<b>Title:</b>	<b>Husky 3 Foam Pump – GEN 1 Pump Discontinued</b>			
<b>Number:</b>	SB_446	<b>Release Date:</b>	06/24/2019	
<b>Revision Number:</b>	4	<b>Revision Date:</b>	02/04/2025	
<b>Chassis Type:</b>	All chassis types			
<b>Component Description:</b>	Husky 3 Foam pump redesign, Gen 1 to Gen 2			
<b>Parts:</b>	*Discontinued* GEN 1 Husky foam pump, PN 2851584 GEN 2.1 Husky 3 foam pump, PN 4503618 GEN 1 to GEN 2.1 replacement kit, PN 3411256

**SERVICE BULLETIN #446.4**

Figure 1

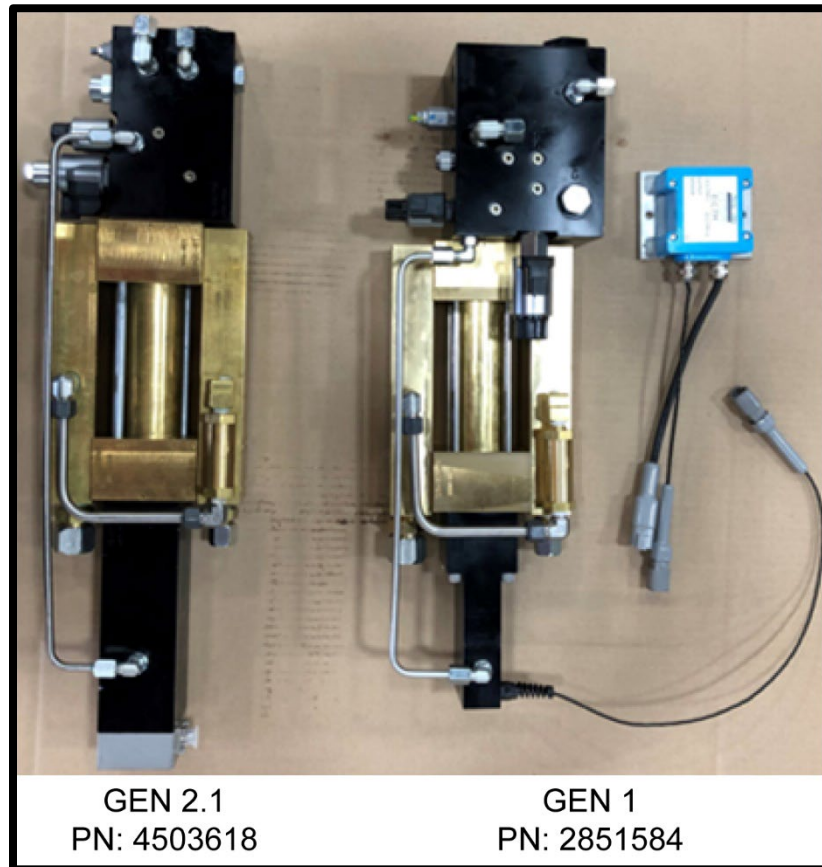
The “old” GEN 1 Husky 3 foam pump (PN: 2851584) uses a blue box signal conditioner for the position transducer in the foam pump, the “new” GEN 2.1 Husky 3 foam pump (PN: 4503618) uses a transducer that does not require a signal conditioner. (See Figure 1)

In the event you need to replace a GEN 1 pump, a conversion kit is available which includes the GEN 2.1 foam pump and 2.1 harnesses which will allow a direct install.

- “Old” Pump = GEN 1 Husky 3 foam pump = PN 2851584
- “New Pump = GEN 2.1 Husky 3 foam pump = PN 4503618
- Conversion kit from GEN 1 to GEN 2.1 Husky 3 foam pump = PN 3411256
  - Includes:
    - 1pc GEN 2.1 Husky 3 Pump (Reference PN 4503618)
    - 1pc Linear Feedback Sensor Adaptor Harness (Reference PN 3599440)
    - 1pc Signal Conditioner Delete Adaptor Harness (Reference PN 3599442)
